# Wollongong Local Planning WLPP Assessment Report | 12 December 2018

<b>WLPP No.</b>	Item No. 3
<b>DA No.</b>	DA-2018/848
<b>Proposal</b>	Residential – Demolition of existing structures and construction of multi dwelling housing – four (4) townhouses
<b>Property</b>	Lot 10 DP 1107164, 11 Catherine Street, Gwynneville
<b>Applicant</b>	ADM Architects
<b>Responsible Team</b>	Development Assessment and Certification - City Centre Team (RW)

## ASSESSMENT REPORT AND RECOMMENDATION

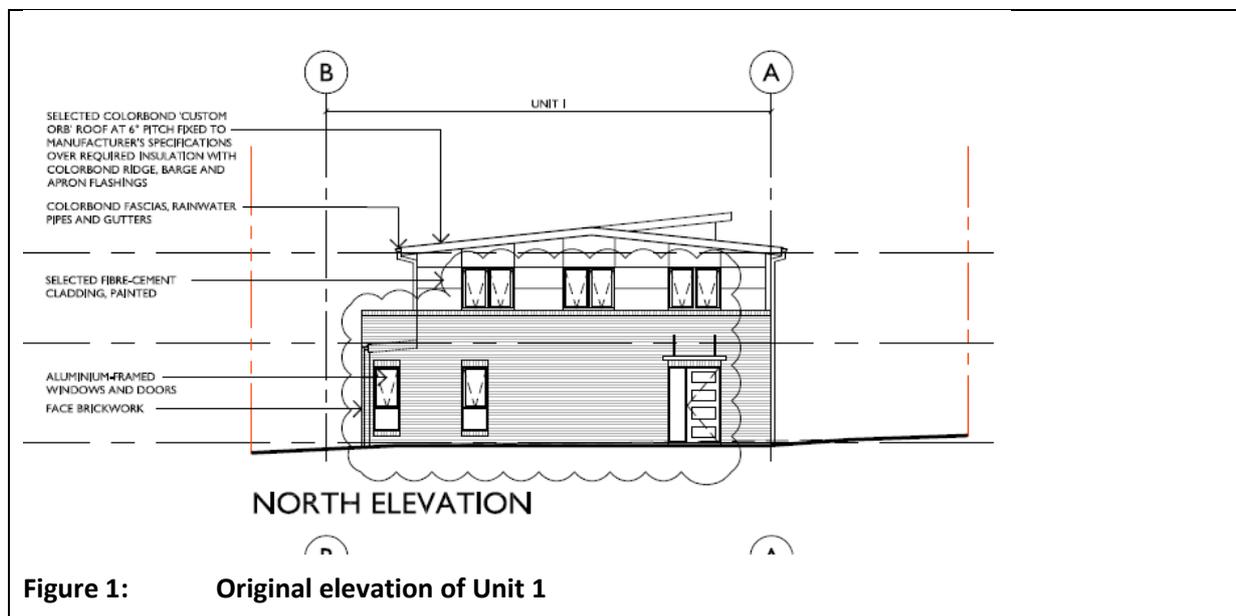
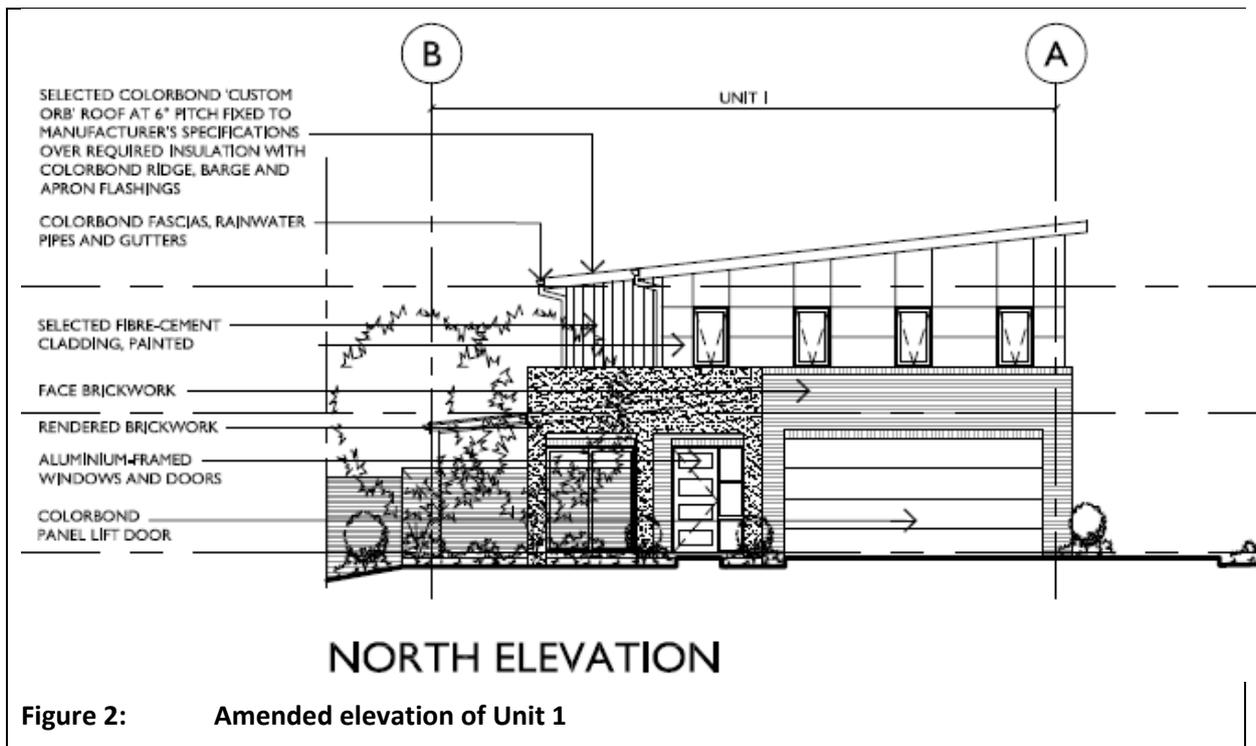
- *Whether the driveway could be relocated to the eastern boundary, so as to align with stormwater easement and to minimise impact on the significant tree located near the western boundary.*

The applicant's justification is considered reasonable based on the site conditions and adjoining development, particularly regarding the solar access and potential impacts on the significant tree.

The amended design retains the driveway on the western side of the site. The applicant has provided the following justification for this layout:

- The stormwater easement is not on the subject property. It only connects into the subject property. Therefore, its location is inconsequential to the proposed layout.

- The stormwater lines from Unit 1 and 2 drain to Catherine Street and would conflict with the tree protection zone if the proposal is mirror reversed. Refer stormwater concept plans by Jones Nicholson.

- The driveway on the eastern side would result in the building envelope of Unit 1 being located far closer to the tree than currently proposed. The amended proposal (& in particular the redesign of Unit 1) increases the setback between the tree and the proposed building envelope and associated driveway.

- Relocating the driveway to the eastern side would result in the POS of each unit being located closer to the adjoining 2 storey building (which is also 600mm closer to the boundary than the single storey building along the eastern side). This would result in greater overshadowing of the POS.

- For the above mentioned reasons, it is the proponent's preference and opinion that in this instance it is reasonable and appropriate for the POS to remain along the eastern side and the driveway along the western side.

Figure 4: Amended floor plan of Unit 1

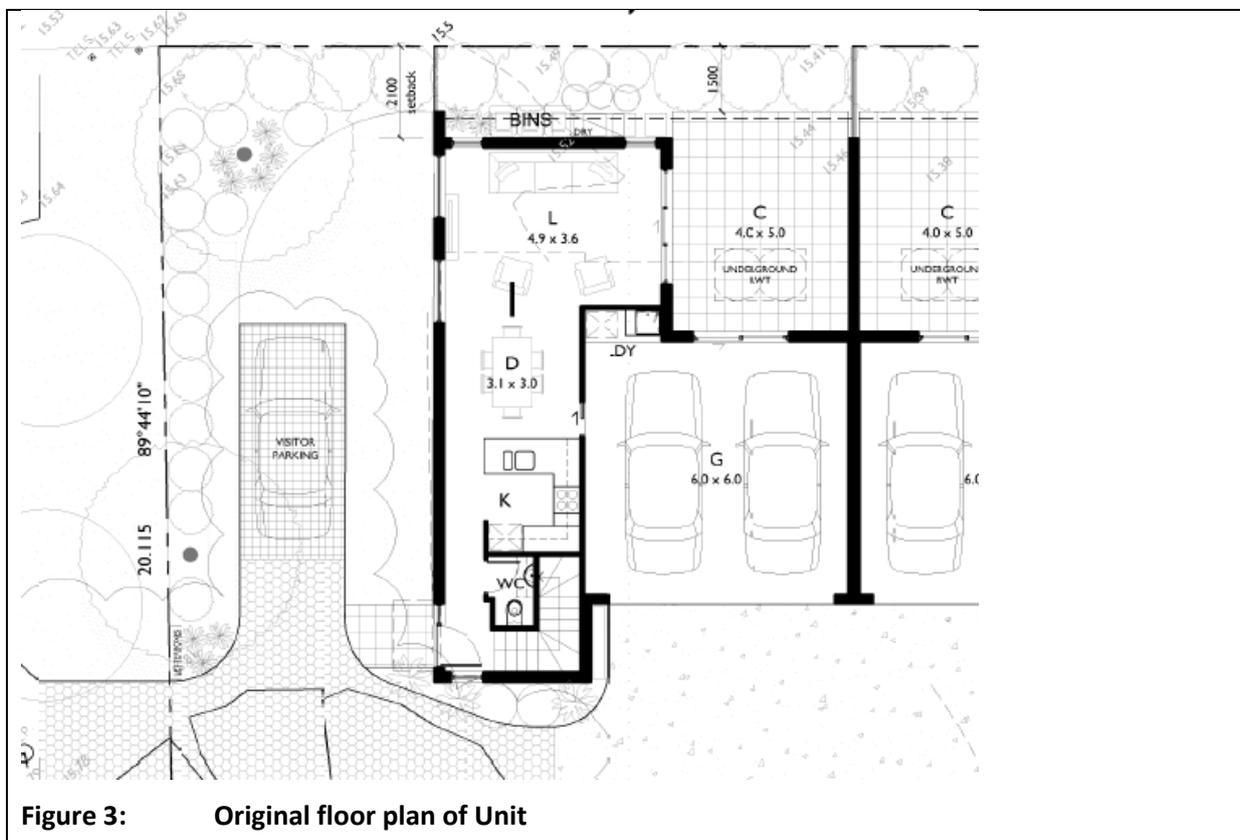
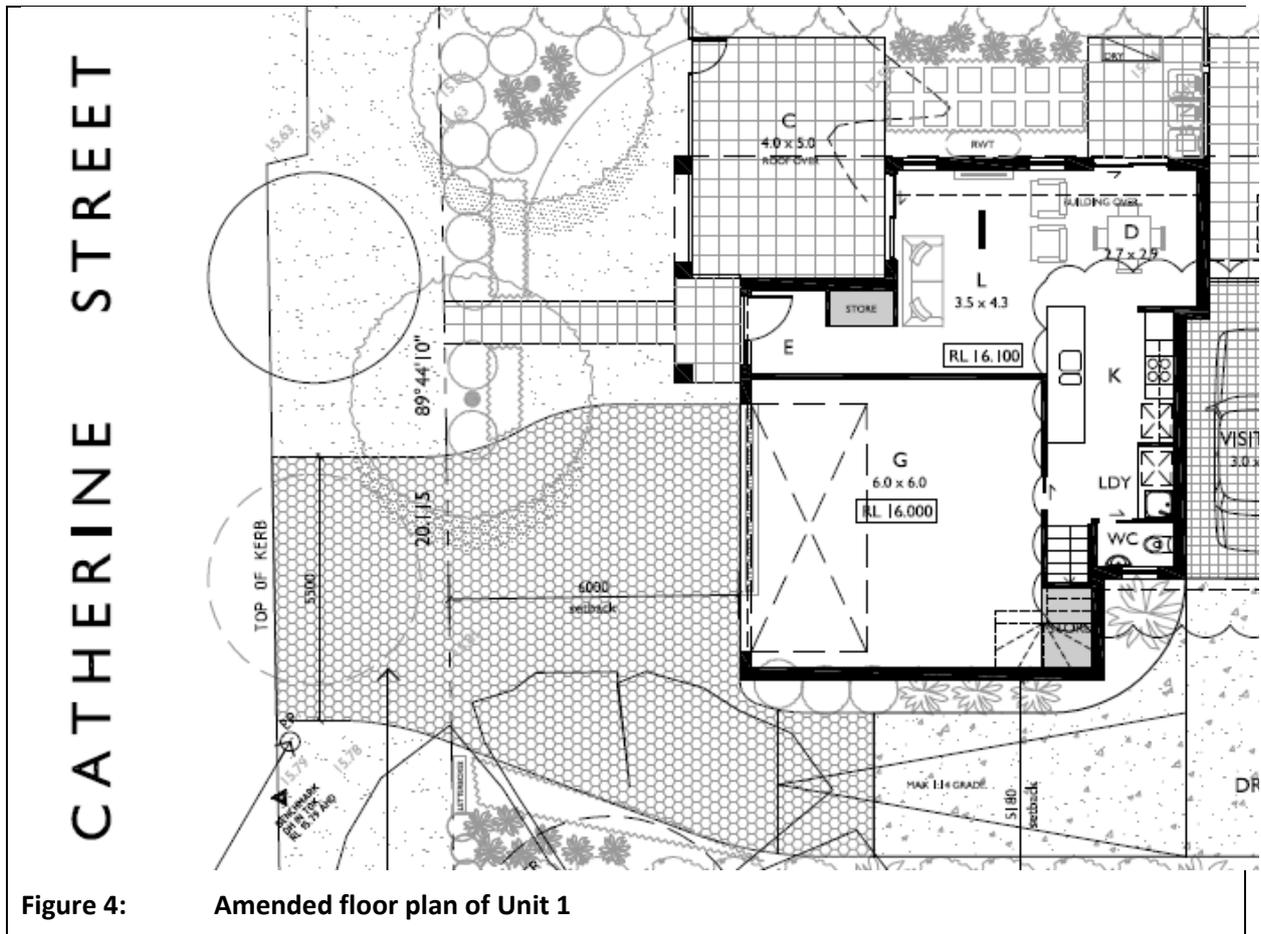
- *The unacceptable internal amenity resulting from the failure to take advantage of the northern aspect available to Unit 1*

The amended layout provides glass sliding doors facing north to maximise solar access from the north (i.e. Catherine Street). The private open space has been relocated to maximise northern sunlight access.

**Figure 6: Proposed site layout – visitor car space proposed between Units 1 and 2**

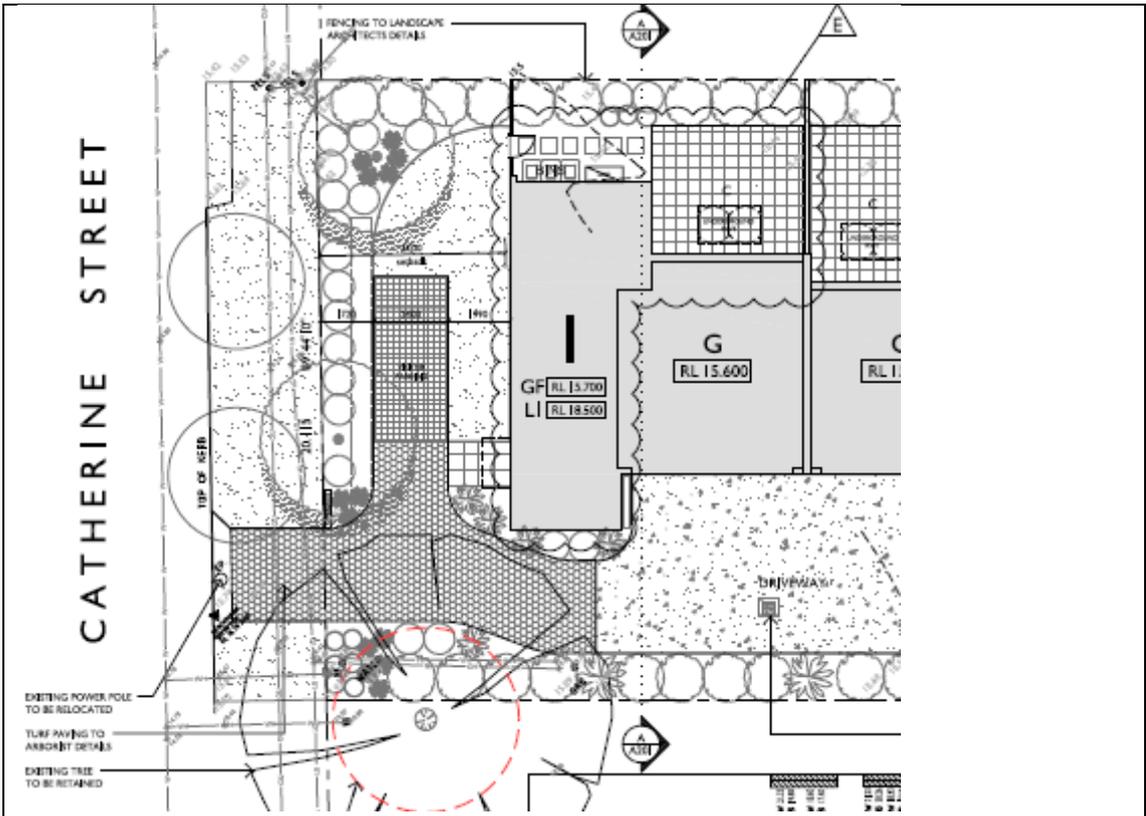
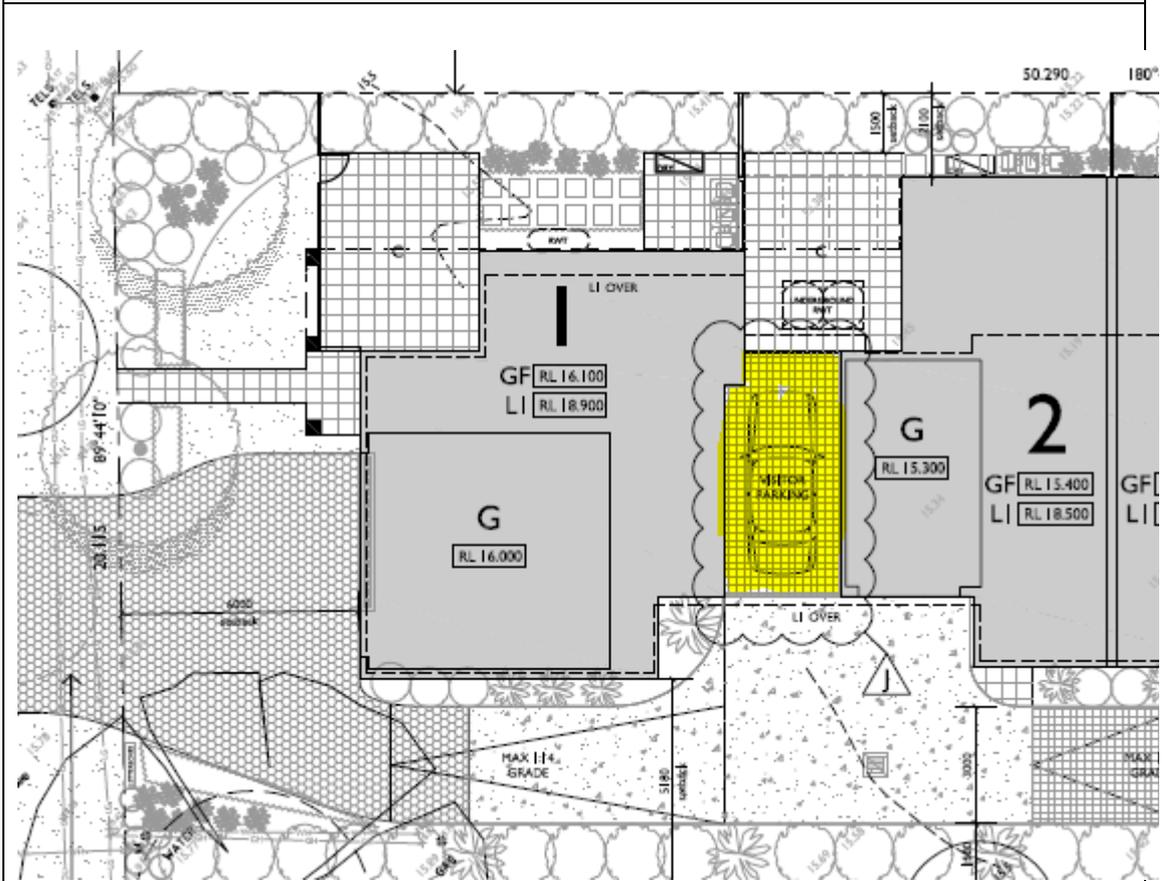
- *The amenity and streetscape impacts arising from providing the visitor space within the front setback. Also the main entry to Unit 1 conflicts with the reversing manoeuvre required for the visitors space raising safety concerns.*

The amended design provides access to a double garage for unit 1 with the common driveway access to the west. Although this results in a relatively large area of hard surfaces, the pedestrian access to Unit 1 has been separated to avoid conflict. The location of the visitor car space is not obvious to first time visitors, and could easily be adopted by the residents of the Unit 2, therefore suitable signage to identify this space as a visitors' space is recommended. A condition for the visitor space to be part of common property and separated from Unit 2's private open space area by way of a solid wall is also recommended.

Given the driveway to Unit 1's double garage and the driveway servicing the rear units is shared, a condition is also recommended for the driveway in front of Unit 1's garage to be kept clear at all times and not used for stack parking (to maintain adequate vehicle access and sightlines).

18 A solid masonry wall must be provided to separate the visitor car space from Unit 2's private open space area. The wall must be full height to minimise any noise and amenity impacts on the occupants of Unit 2. This requirement shall be reflected on the Construction Certificate plans.

**Figure 8:** Proposed level change between Units 2 and 3 with reduced 1:14 grade between Unit 1 and Unit 2

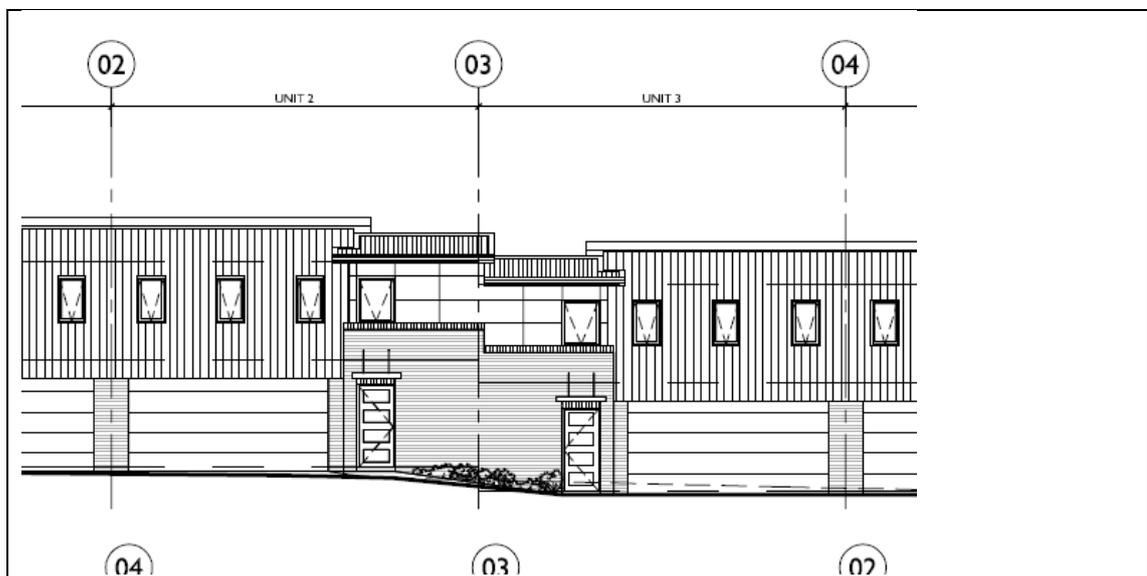
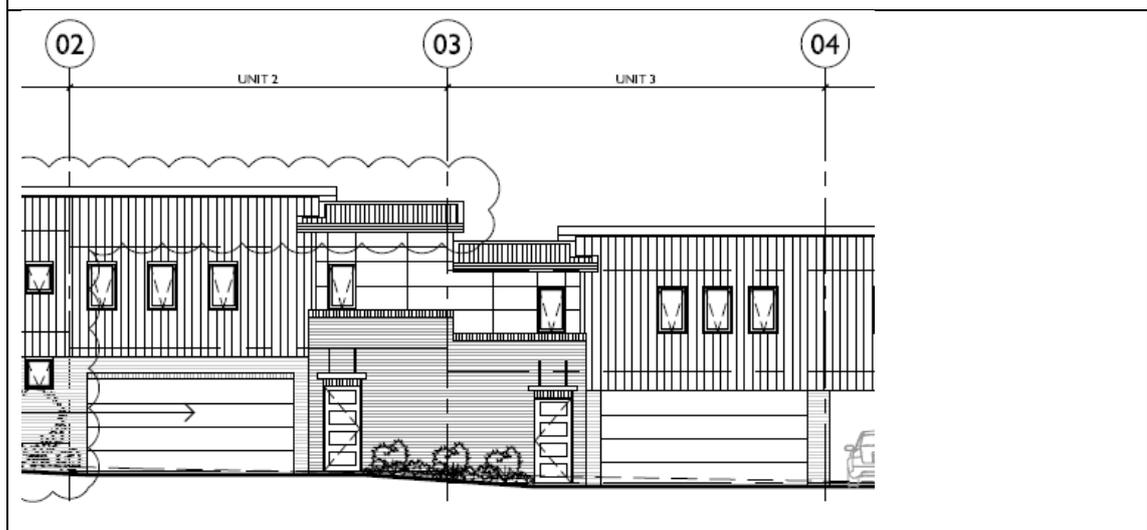
- *The gradient of the driveway in the vicinity of units 2 and 3 which directly impacts on the pedestrian access to their front entries*

The change in level between Units 2 and 3 has reduced from a 600mm difference to 300mm (i.e. from 1:8 to 1:14). The proposed level change is not considered to compromise suitable pedestrian access to these units. It is noted that satisfying the garage levels adjacent to these pedestrian entries results in the driveway gradient in front of these units.
